NHS-0000-00(425), Hall County
P.I. No. 0000425
I-985 New Interchange N of SR 13 Crossover Near Martin Road

Re: **Responses to Concept Report**

This letter is in response to the comments for the concept report regarding Project NHS00-000-00(425), P.I. No. 0000425 in Hall County. Please see the responses below to the concept report.

PROJECT CONCEPT REPORT

**APPLIES TO NEW INDUSTRIAL CONNECTOR ROAD
(FROM THURMON TANNER PKWY TO SR 13/ FALCON PARKWAY) AND
THURMON TANNER PKWY**

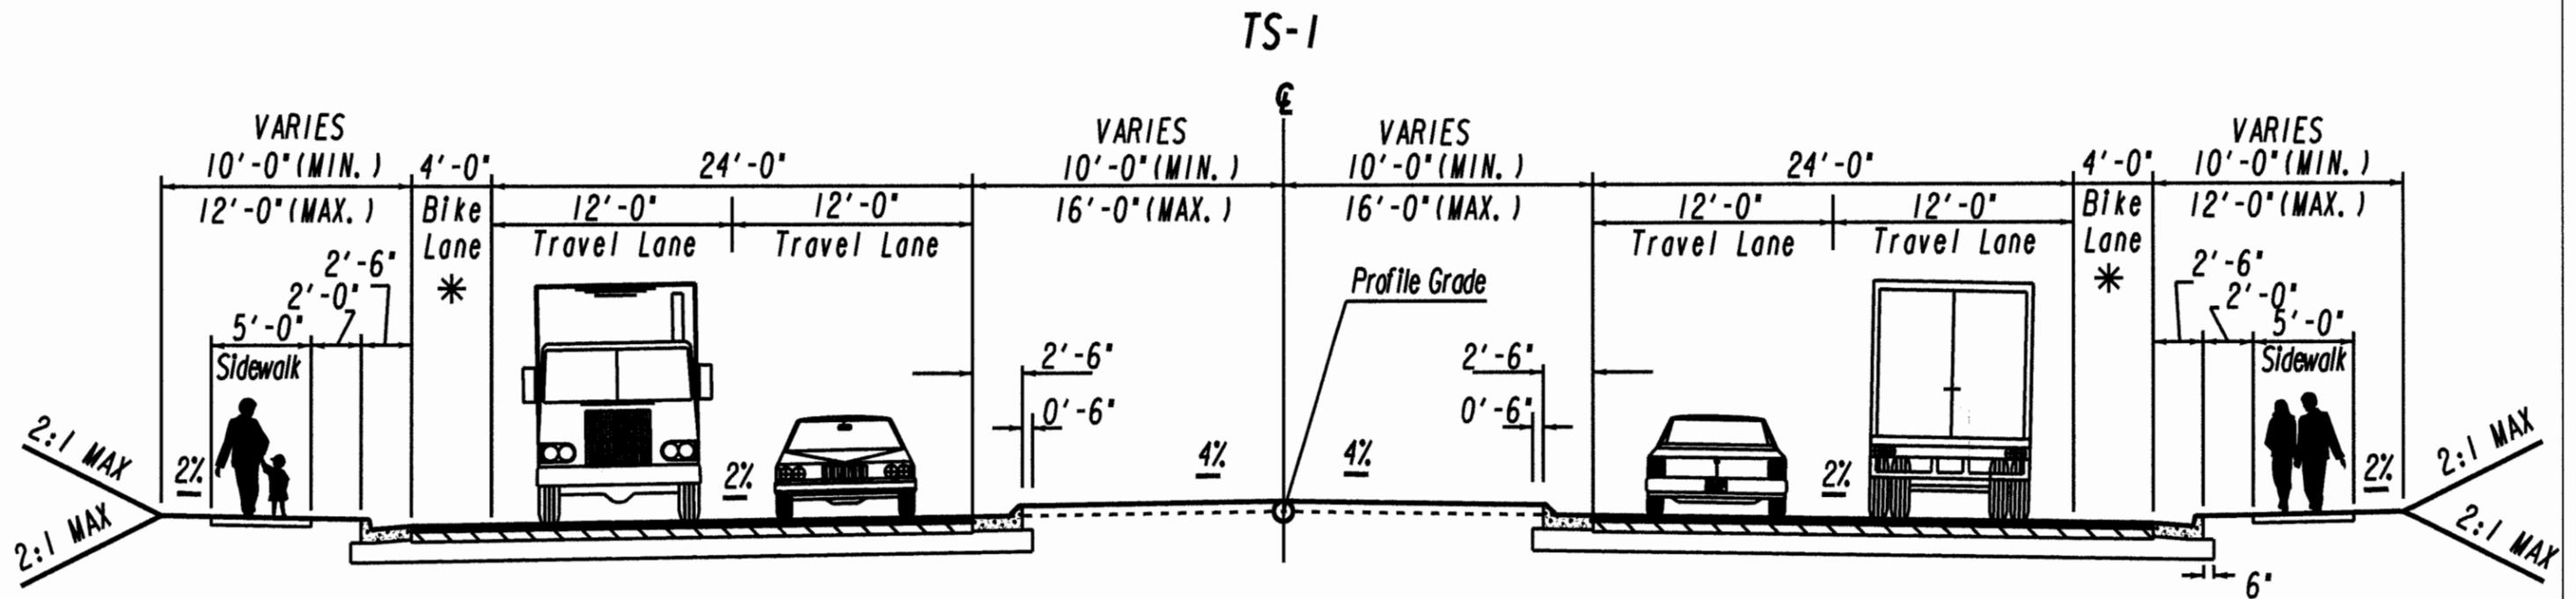
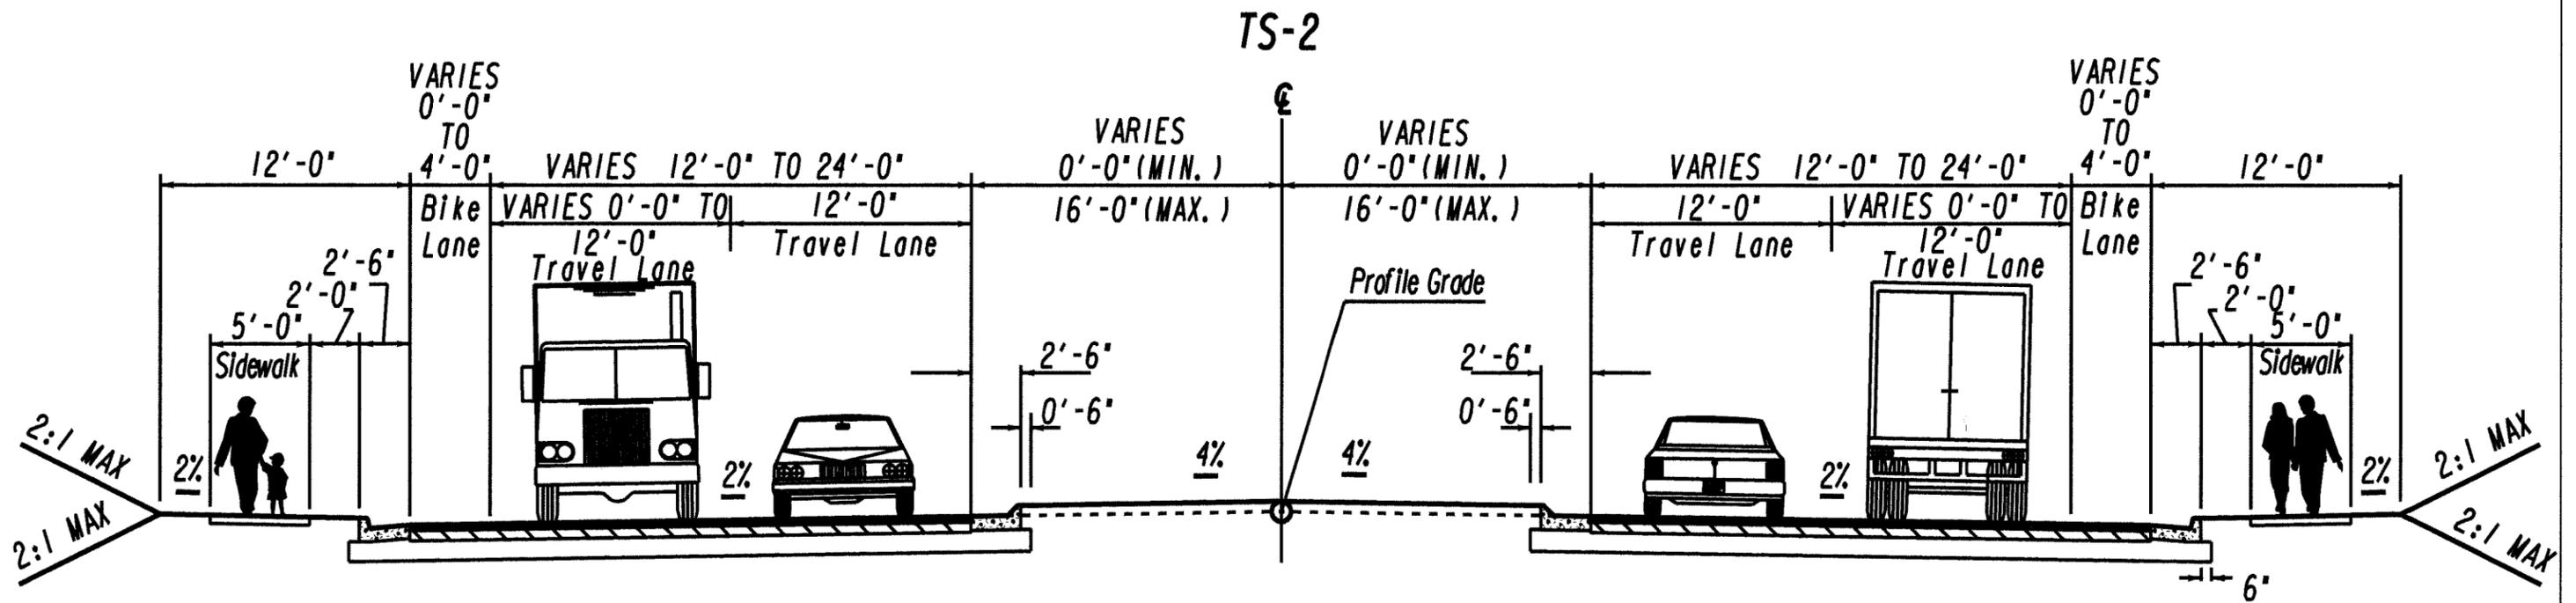
3. Need to study Full Access to Fire Station from SR 13. The Consultant stated that driveway to Fire Station is very close to intersection.
4. SR 13 is on State Bike Route. Need to revise typical section for SR 13.

4. Page 13: Why are bike lanes not included on Martin Road Extension/New Industrial Connector Road? Do bike trails currently exist or are there any plans for bike trails on the west side of I-985? If so, how do they connect with the bike lanes along SR13?

The Gainesville Hall County Metropolitan Planning Organization's (GHMPO) bike and pedestrian plan, adopted in 2006, does not recommend bicycle facilities along Martin Road Extension/New H.F. Reed Industrial Connector in the GHMPO Plans.

The concept will be updated to provide for bike lanes on H. F. Reed Industrial Parkway, Martin Road and S.R. 13 (Falcon Parkway) within the project limit.
